LAND DEPARTMENT.

FILE No. 7 of 1928

PLAN SHOWING PROPOSED BUILDING TO BE BUILT
ON PLOT NO 4 SHEET NO 18, JAIL QUART

Re: Plot No. 4 Sheet J.D-8 Quarter Jail

= PLAN SHOWING PROPOSED BUILDING =

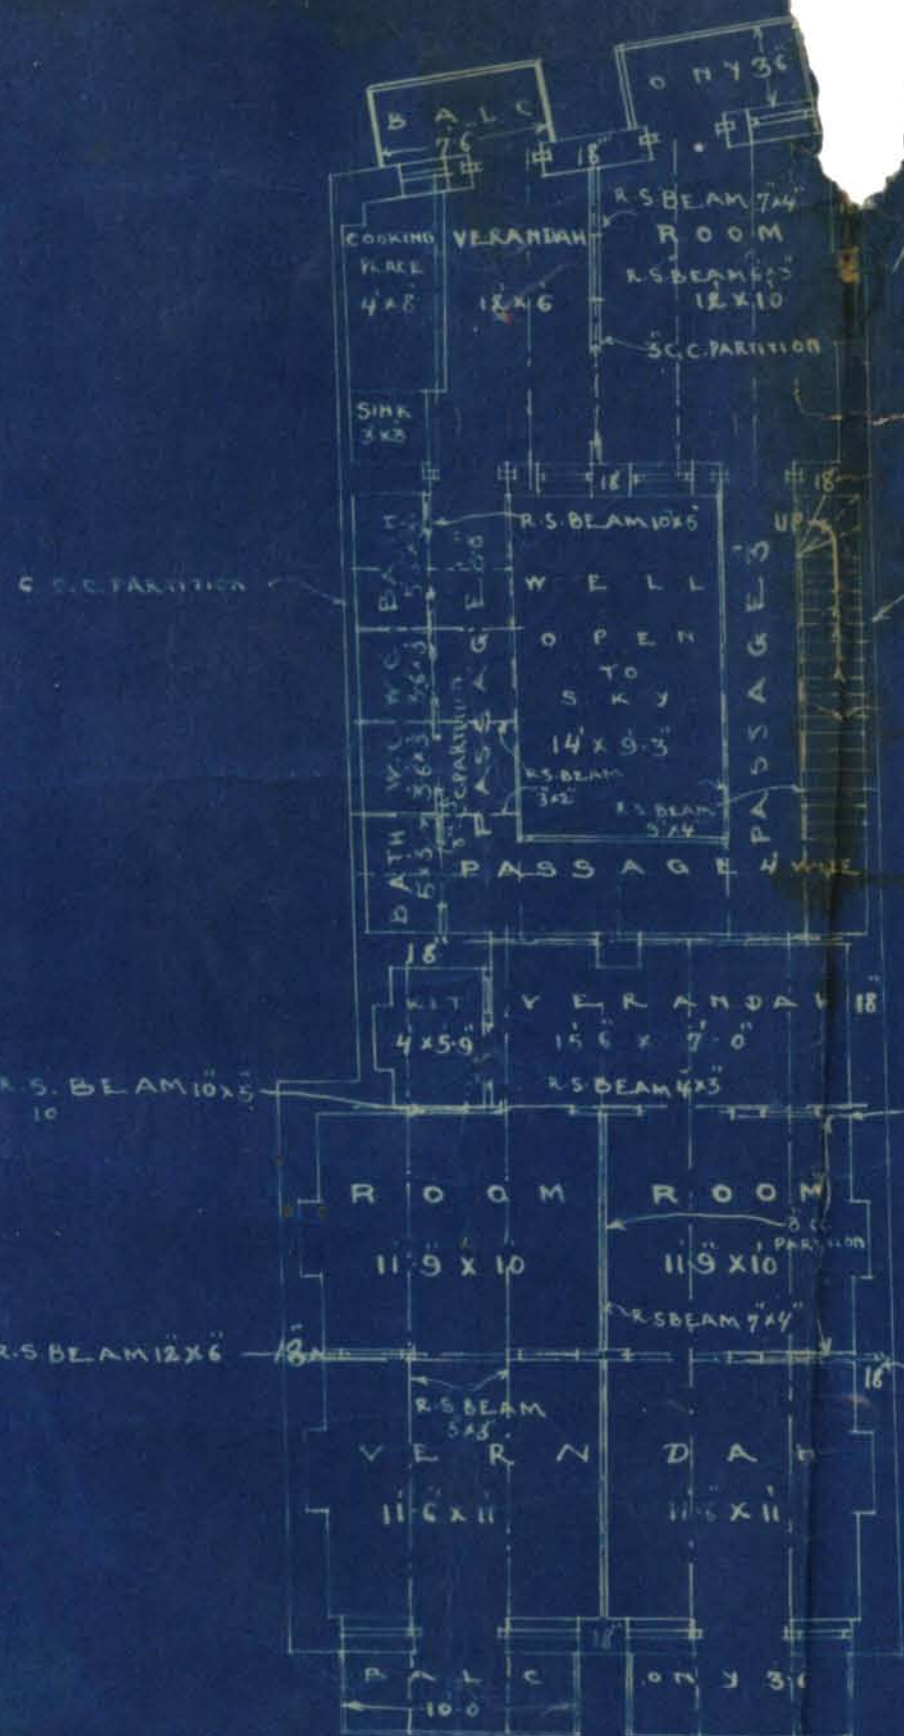
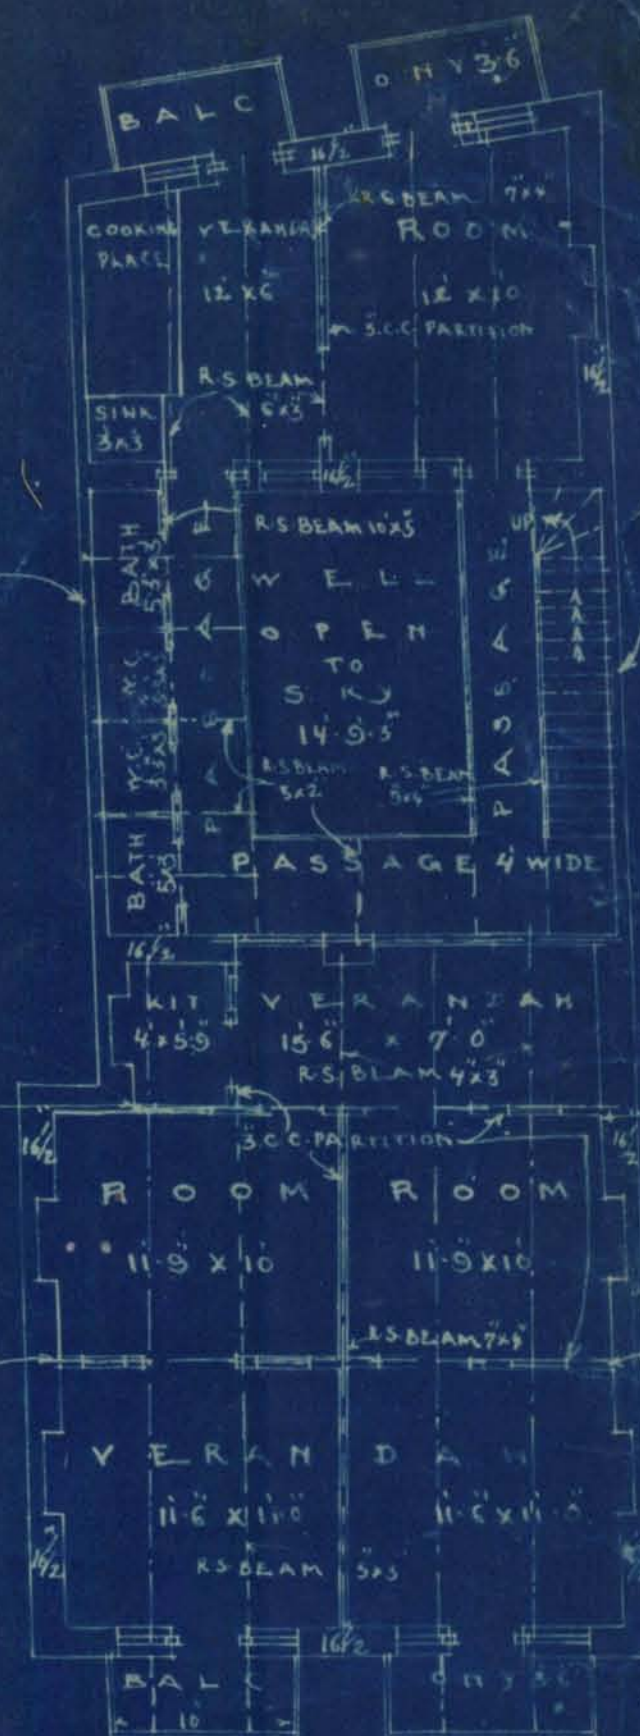
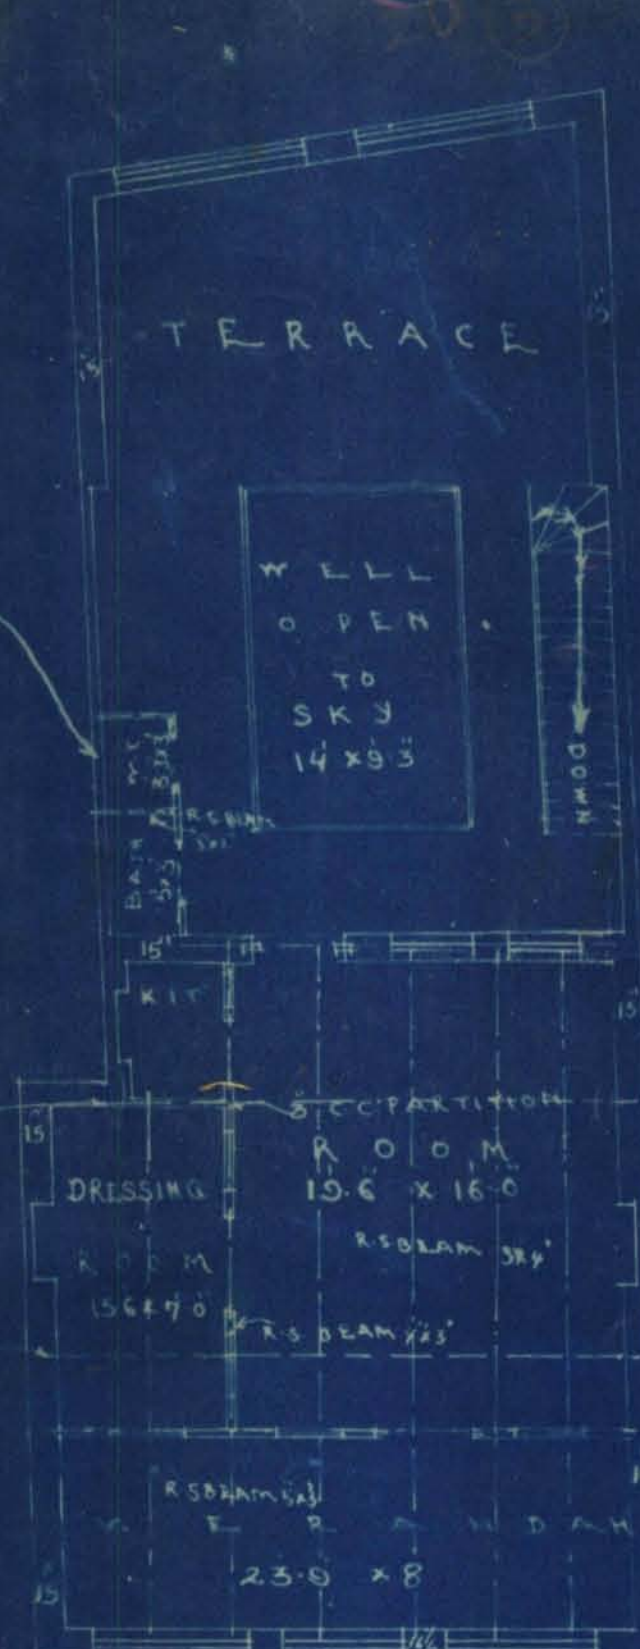
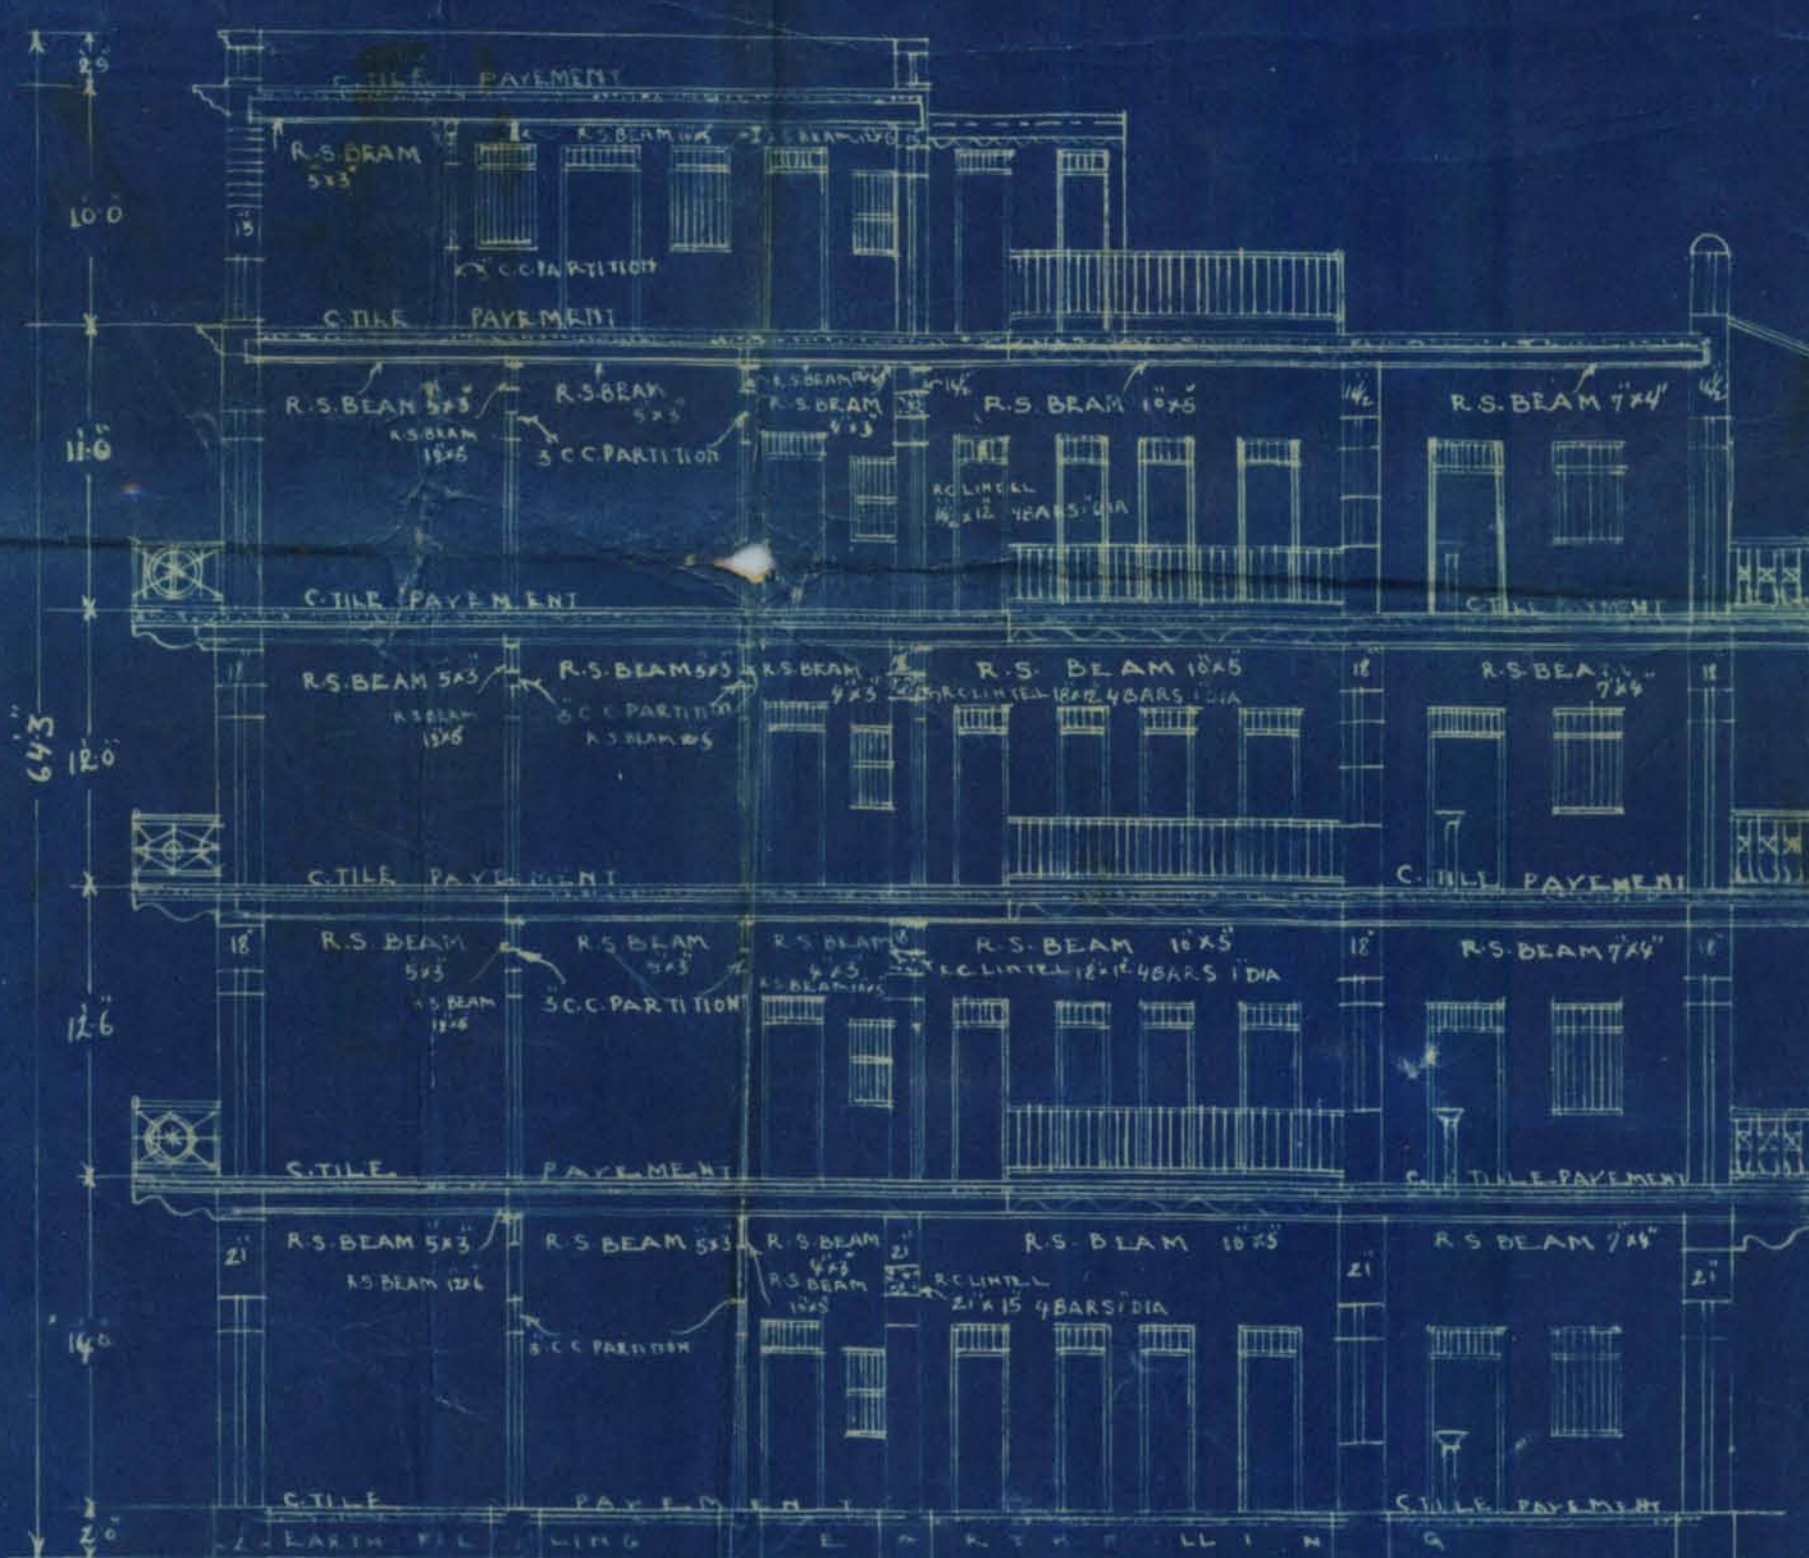
- (1) Plans must be submitted by a licensed Surveyor.
- (2) External walls should be throughout of full thickness. More than ground and 3 upper cannot be allowed.
- (3) R.S. Beams shall be of large size.
- (4) Inner rooms are not well ventilated; whole of one side at least should abut on open space.
- (5) Verandah and beyond that passage cannot be allowed.
- (6) D.R.E. must be left open to sky; passage must be omitted.
- (7) Thickness of walls are insufficient.
- (8) Separate plans should be submitted for balconies.
- (9) _____

Inner rooms are not well ventilated
whole of one side at least should
be on open space

(1) External walls should be throughout of full thickness(2) Cabin on top of 3rd floor cannot be allowed(3) Thickness of walls is insufficient. It should be as follows 23 1/2" for one storey 18 1/2" for next two and 14" for the rest.(4) R. S. Beams shall be of larger size(5) Plans must be signed by an architect holding licence from the Municipality.Date 13-6-28
Building Surveyor.no objection
KMR
19/11/28

(1) Plans have been signed by the undersigned.

(2) Cross walls ~~have~~ 28" thick have been
provided at 9' apart and then 6" cement
concrete walls have been provided in
between and I believe the municipal
byelaw has ^{therefore} been fully observed.

- 16
- (3) only Ground and 3 above floors are provided and ~~so~~ Top floor has been deleted. The roads are 80' and 40' wide in front and rear respectively.
- (4) R. S. beams are kept of larger sizes.
- (5) & (6) passage is removed and portion E is made open to sky. This arrangement thus is in accordance with municipal rules. The room also on front Verandah whose facing is open ~~more than half~~ ^{7' wide only}. The rear Verandah is ~~also~~ ^{7' wide only} which is made through and abuts on open ~~are~~ air well and portion marked E.
- (7) Thickness of walls are made sufficient
- (8) separate plans shall be submitted for balconies on rear but on front the old balconies are already standing and are 30 years old and therefore the Landlord has easement right on this land.
- Yours faithfully
L. N. L.
